ADDENDUM

Project: Arlington Woods Free
Methodist Church Renovation

Addendum No.: A01

Date: August 07, 2020

000.07

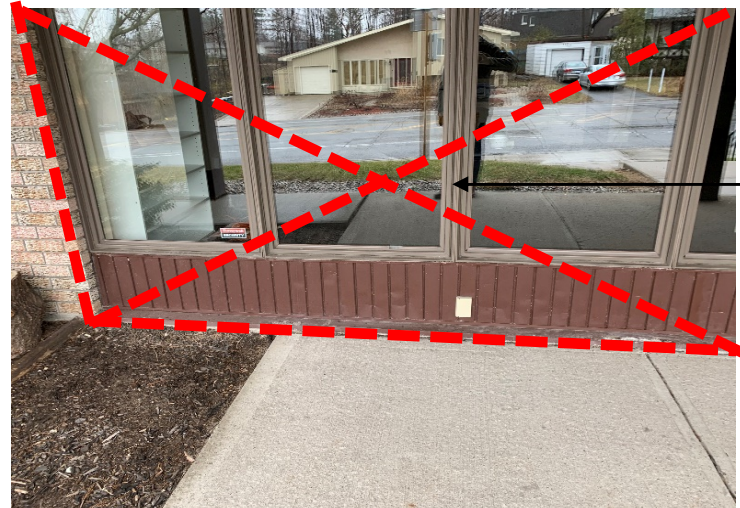
Provide separate price to remove and re-clad metal fascia around full extent of canopy beams.

ADD01.02

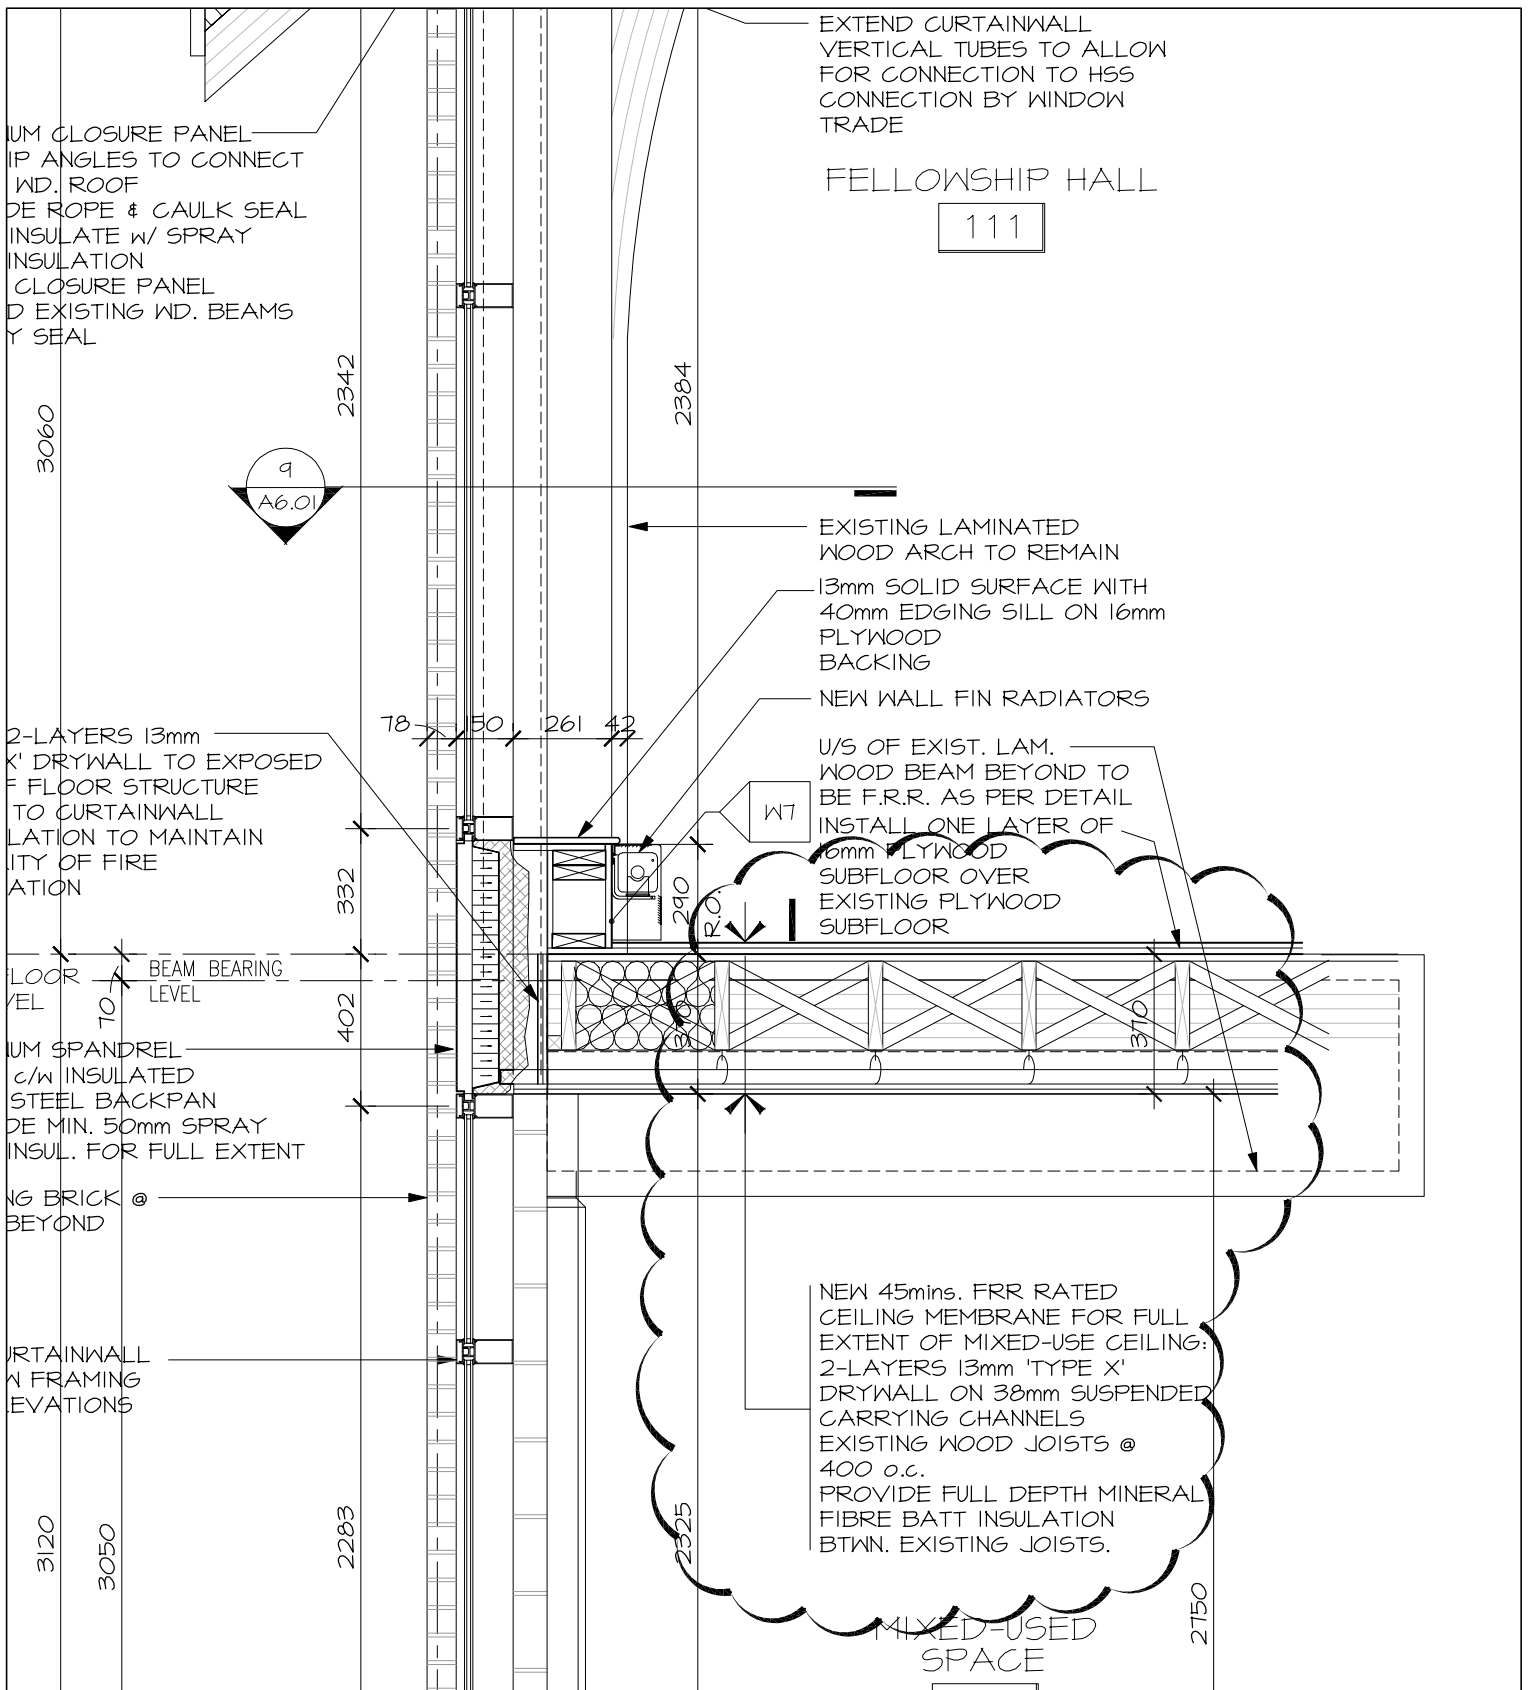
A1.2 Drawings		
A1.2.1	1/A2.02	<p><u>Ground Floor Demolition Plan:</u> See enclosed Architectural Sketch ADD01.01 for revised extent of shelving removals in Janitor Rm. 108 to accommodate new 24" x 24" mop sink and 24" dia. hot water tank per Mechanical Drawings. Cut shelving to suit plumbing fixtures and make good remaining portion of shelving.</p>
A1.2.2	2/A2.03	<p><u>Basment RCP – New Work Plan:</u> Provide new gypsum board bulkhead for full extent along Grid 4 between Grids K & M to enclose breaching pipes penetrating existing wall from adjacent boiler room. Breaching pipes re-routed vertically to floor above. Bulkhead concealing breaching pipes not required to be a fire-separation provided alternate fire separation is provided (ie/ fire wrap blanket per Item A1.1.1 or horizontal shaftwall).</p>
A1.2.3	1/A2.04 2/A4.01	<p><u>Ground Floor New Work Plan:</u> See enclosed Architectural Sketch ADD01.02 for extent of new impact isolation underlayment to be applied over plywood sheathing in Fellowship Hall 117. Product: AcoustiGuard QT4005, 5mm thick, 0.75psf.</p> <p><u>Fellowship Floor Assembly: (See enclosed Architectural Sketch ADD01.03)</u></p> <ul style="list-style-type: none"> • LVT flooring • 5mm impact isolation underlayment • 16mm plywood subfloor • Existing plywood subfloor • Existing 38 x 235 wood joists spaced @ 406mm centres • Min. 200mm depth mineral fibre acoustic batt insulation between joists. • Mesh screen or retention strips to keep insulation in place • 38mm suspended metal furring channels @ 406mm centres. • 2-layers 13mm Type 'X' gypsum board for full extent of Mixed Use Space 018 & Kitchen 019 to achieve min. 45mm FRR. Seal all penetrations through ceiling membrane. Fully seal all mechanical & electrical penetrations through Fellowship Hall Floor with rated sealant.

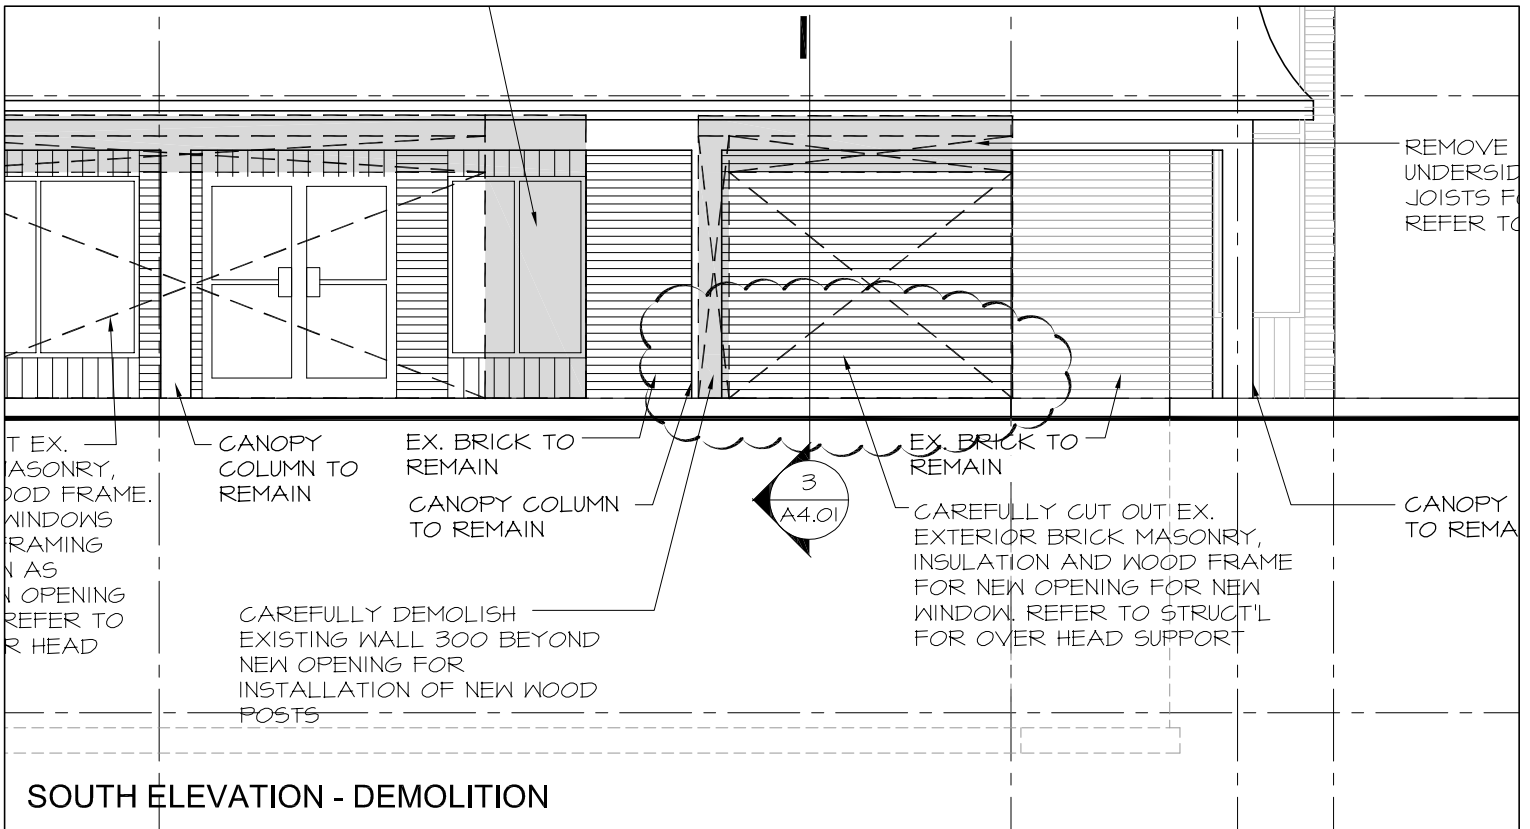
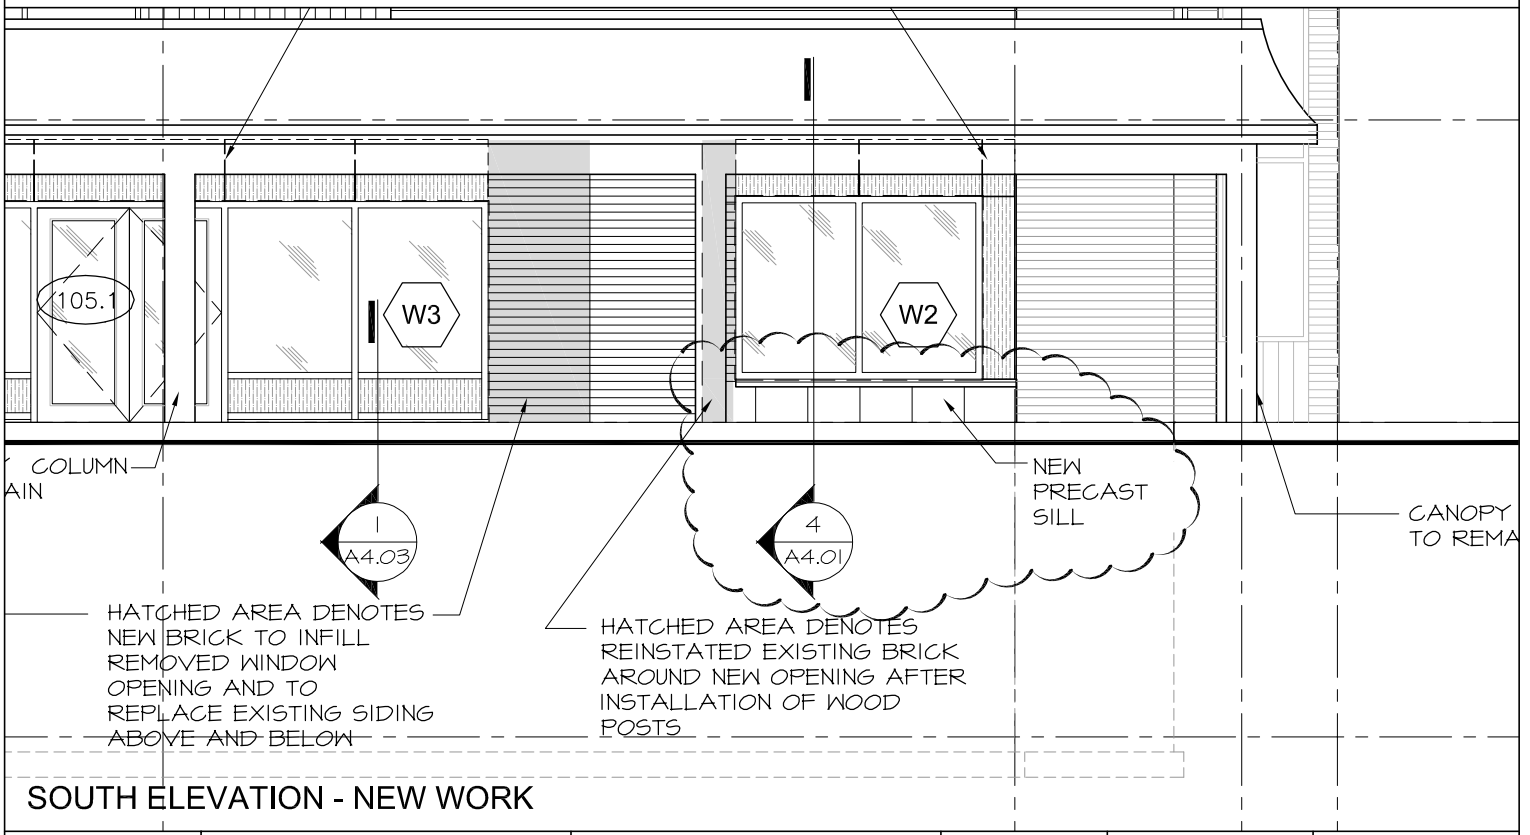
A1.2.4	A3.01 4/A4.01	Demolition & New Work South Elevations: See enclosed Architectural Sketches ADD01.04 & ADD01.07 for revised extent of existing brick masonry below new window opening to be removed. Provide new precast concrete sill complete with prefinished thru-wall flashing and air barrier membrane over existing exterior sheathing per ADD01.04. Refer to Specification Section 03 45 00 for precast unit specifications.
A1.2.5	A3.02	Demolition & New Work West Elevations: See enclosed Architectural Sketch ADD01.05 for extent of existing wood siding infill panels below windows to be removed and replaced with new aluminum closure panels (colour to match curtainwall frames). Refer to Specification Section 08 50 00 for aluminum panel specifications. Provide new parging to exposed concrete brick ledge (painted brown) on south and north elevations. See Architectural Sketch ADD01.05.
A1.2.6	A3.03 4/A4.01	Demolition & New Work East Elevations: See enclosed Architectural Sketches ADD01.06 & ADD01.07 for revised extent of existing brick masonry below new window opening to be removed. Provide new precast concrete sill complete with prefinished thru-wall flashing and air barrier membrane over existing exterior sheathing per ADD01.05. Refer to Specification Section 03 45 00 for precast unit specifications.

DRAWING NAME:
**CANOPY BEAM
DETAIL**

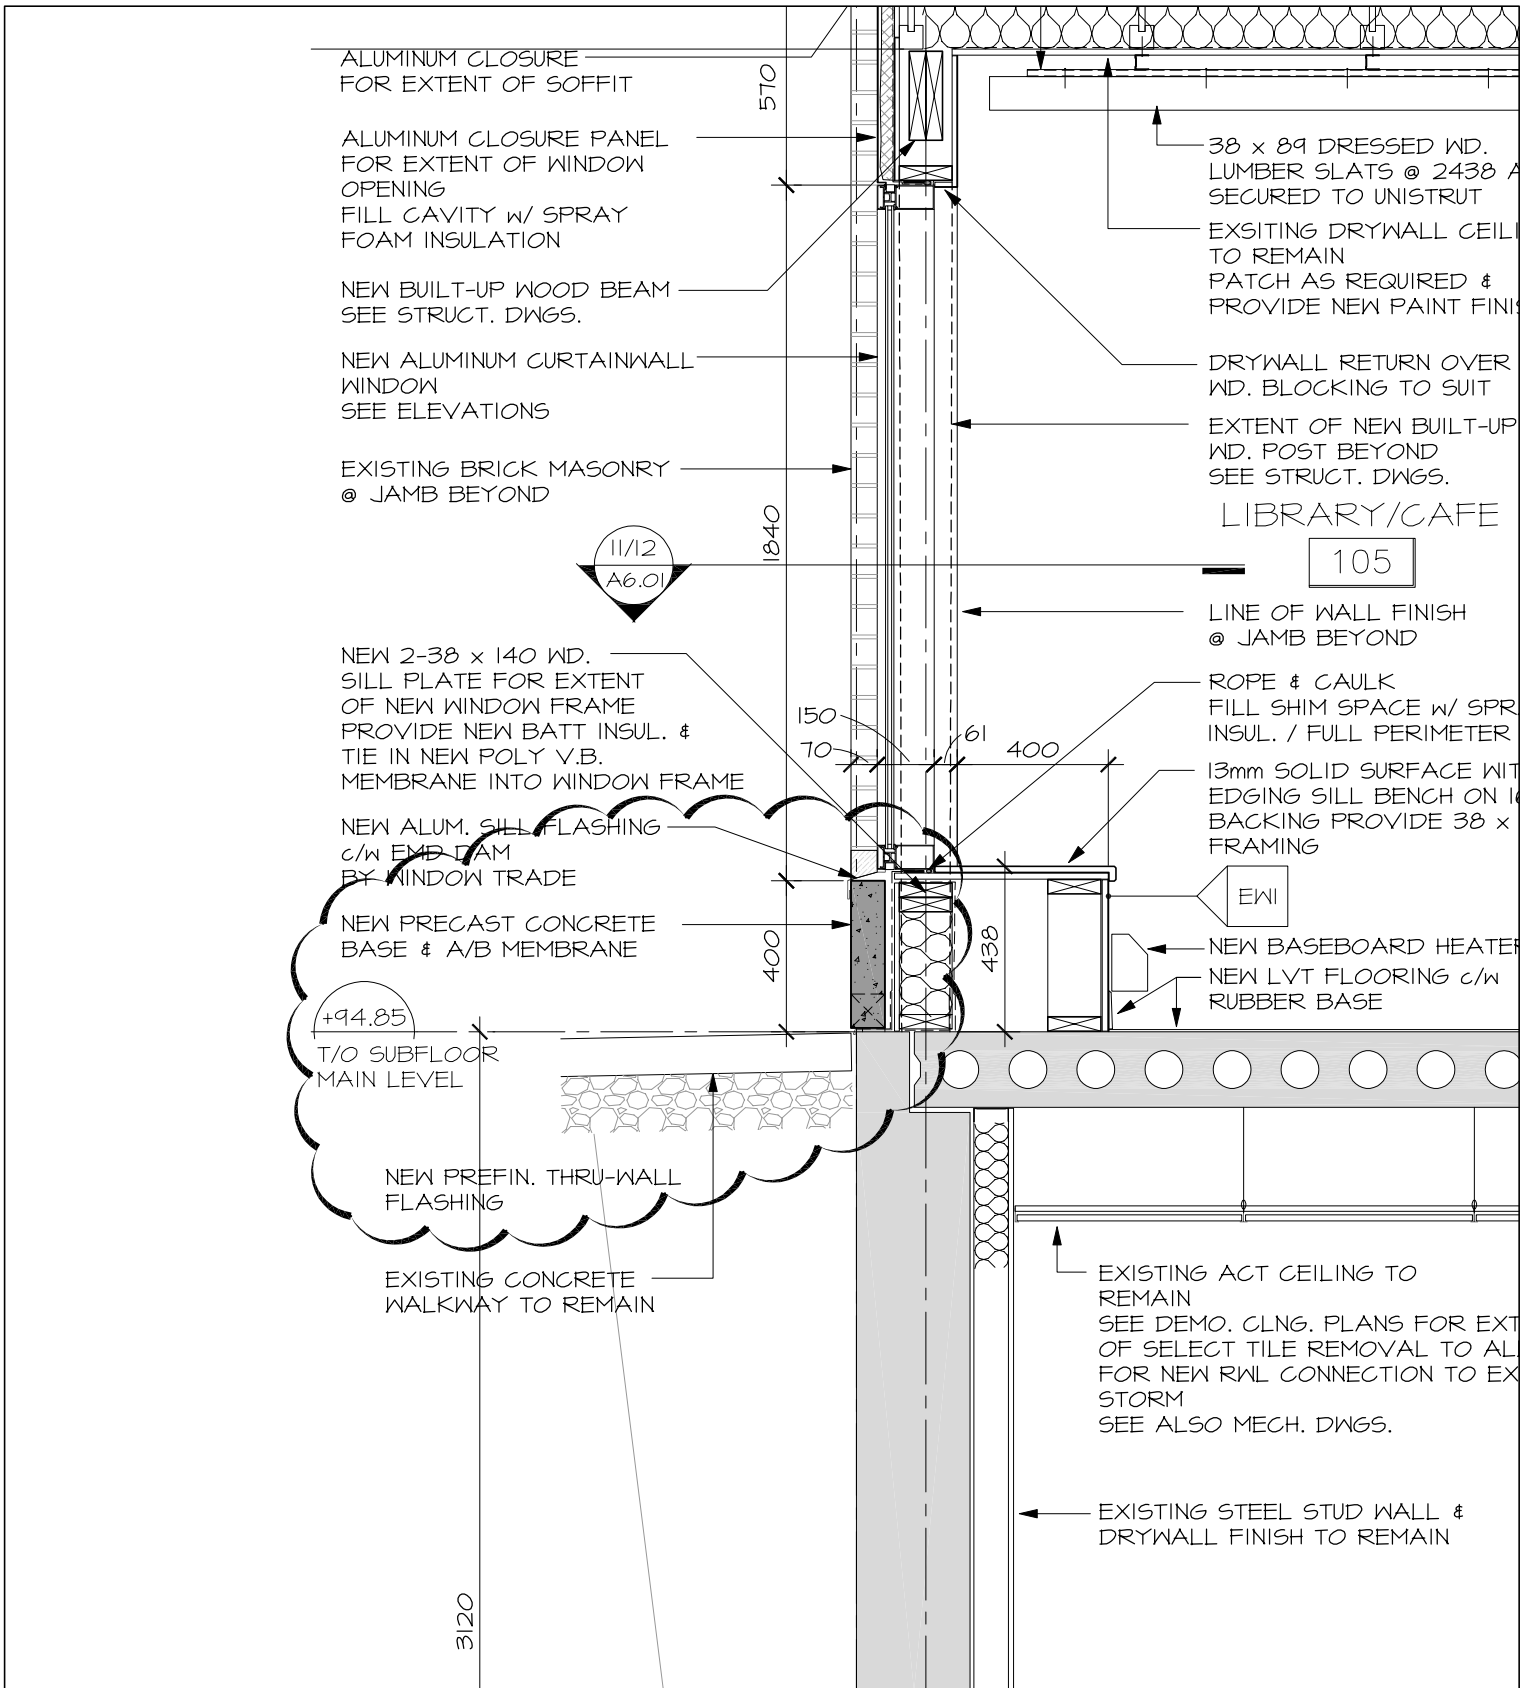
A1.2.7	ADD01.06	Canopy Beam Detail: Provide a separate price to remove existing metal fascia around all main entrance canopy beams and replace with new, stepped prefinished metal fascia per enclosed Architectural Sketch ADD01.08 . Provide stepped fascia cladding over new 19 x 140 continuous wood blocking to reduce oil-canning prevalent in existing installation. Separate price to be included in Separate Price form per Item A1.1.1 above.
A1.3 Mechanical		
A1.3.1	M5	Mechanical Ground Floor HVAC and Utilities Removals & New Work: Contractor to provide parts and labour to remove two (2) residential style range hoods and install two (2) new stainless steel range hoods in current location.

PROVIDE NEW CONT. 19 x 140
EXT. GRADE WOOD
BLOCKING EACH SIDE
OF CANOPY BEAMS TO
REDUCE OIL-CANNING IN
NEW FASCIA

REMOVE EXSTING ALUMINUM FASCIA
FOR FULL EXTENT OF EXTERIOR
CANOPY BEAMS

PROVIDE NEW PREFINISHED METAL
FASCIA FOR FULL EXTENT OF
CANOPY BEAMS
